Docket Nos. 50-280
and 50-281

The Commission has issued the enclosed Amendments No. 7 to Facility Licenses No. DPR-32 and DPR-37 for the Surry Power Station, Units 1 and 2. The amendments include Change No. 22 to your Technical Specifications for each license and are in response to your request dated April 15, 1975, as supplemented May 1 (Proprietary Information appended) May 20, June 6, June 9 and June 11, 1975.

The amendments revise provisions of the Technical Specifications related to the emergency core cooling system (ECCS). These revisions are based on the licensee's reevaluation of the ECCS performance and are consistent with the requirements of 10 CFR 50 Part 50.46.

ATTACHMENT TO LICENSE AMENDMENT NO. 7
CHANGE NO. 22 TO THE TECHNICAL SPECIFICATIONS
FACILITY OPERATING LICENSE NO. DPR-32
DOCKET NO. 50-280

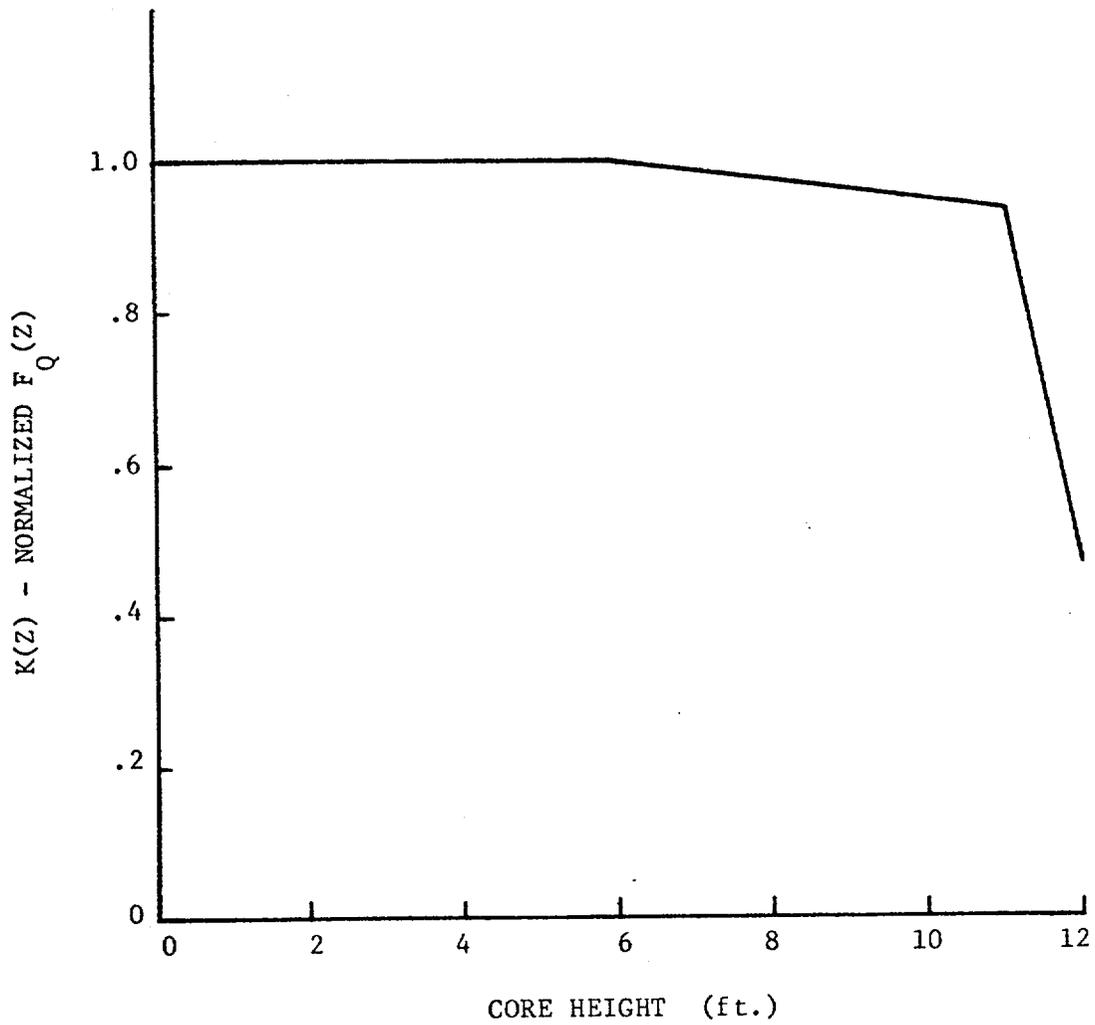
In some instances of rapid unit power reduction automatic rod motion will cause the flux difference to deviate from the target band when the reduced power level is reached. This does not necessarily affect the xenon distribution sufficiently to change the envelope of peaking factors which can be reached on a subsequent return to full power within the target band, however, to simplify the specification, a limitation of one hour in any period of 24 hours is placed on operation outside the band. This ensures that the resulting xenon distributions are not significantly different from those resulting from operation within the target band. The instantaneous consequences of being outside the band, provided rod insertion limits are observed, is not worse than a 10 percent increment in peaking factor for the allowable flux difference at 90% power, in the range +14.5 to -21 percent (+11.5 percent to -18 percent indicated) where for every 4 percent below rated power, the permissible positive flux difference boundary is extended

by 1 percent, and for every 5 percent below rated power, the permissible negative flux difference boundary is extended by 2 percent.

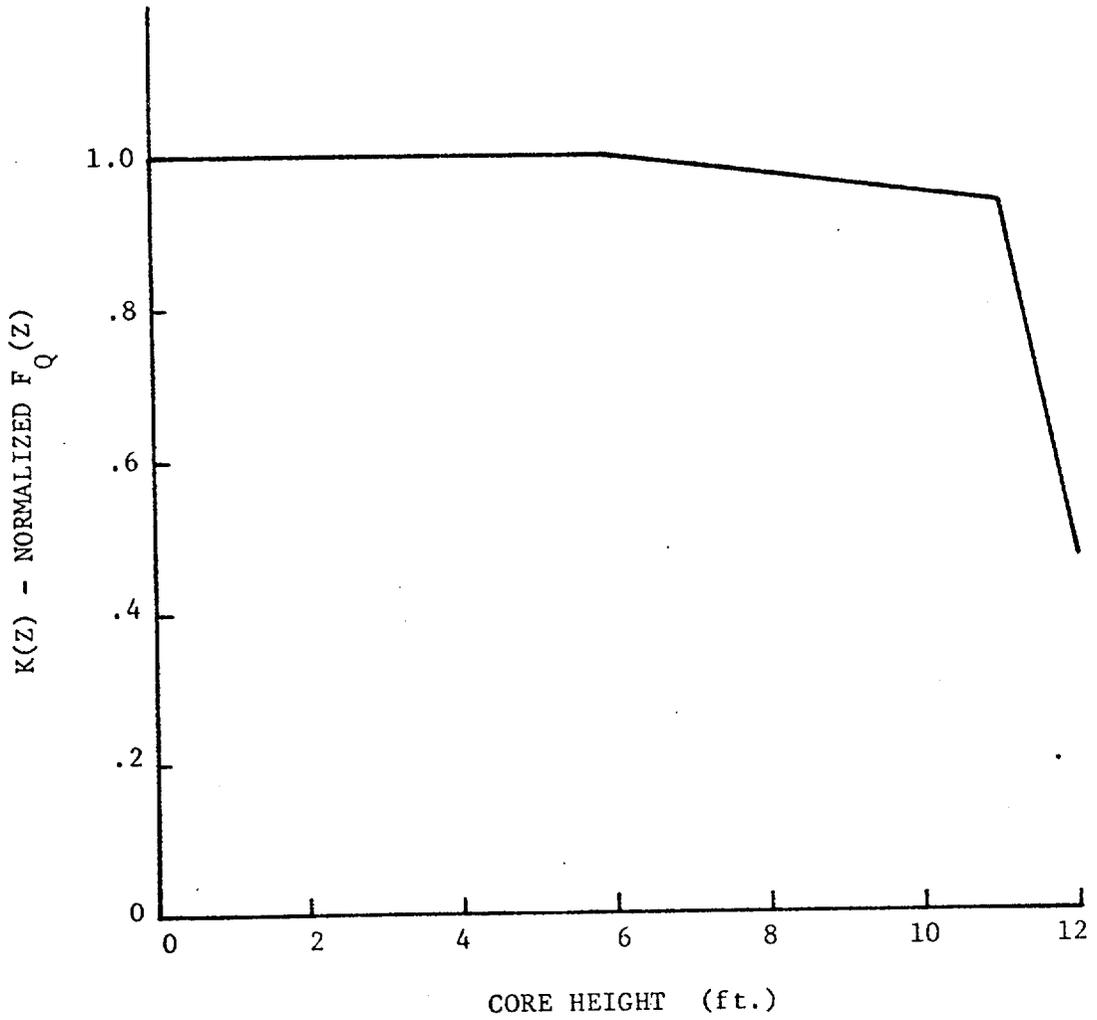
In some instances of rapid unit power reduction automatic rod motion will cause the flux difference to deviate from the target band when the reduced power level is reached. This does not necessarily affect the xenon distribution sufficiently to change the envelope of peaking factors which can be reached on a subsequent return to full power within the target band, however, to simplify the specification, a limitation of one hour in any period of 24 hours is placed on operation outside the band. This ensures that the resulting xenon distributions are not significantly different from those resulting from operation within the target band. The instantaneous consequences of being outside the band, provided rod insertion limits are observed, is not worse than a 10 percent increment in peaking factor for the allowable flux difference at 90% power, in the range +14.5 to -21 percent (+11.5 percent to -18 percent indicated) where for every 4 percent below rated power, the permissible positive flux difference boundary is extended

by 1 percent, and for every 5 percent below rated power, the permissible negative flux difference boundary is extended by 2 percent.
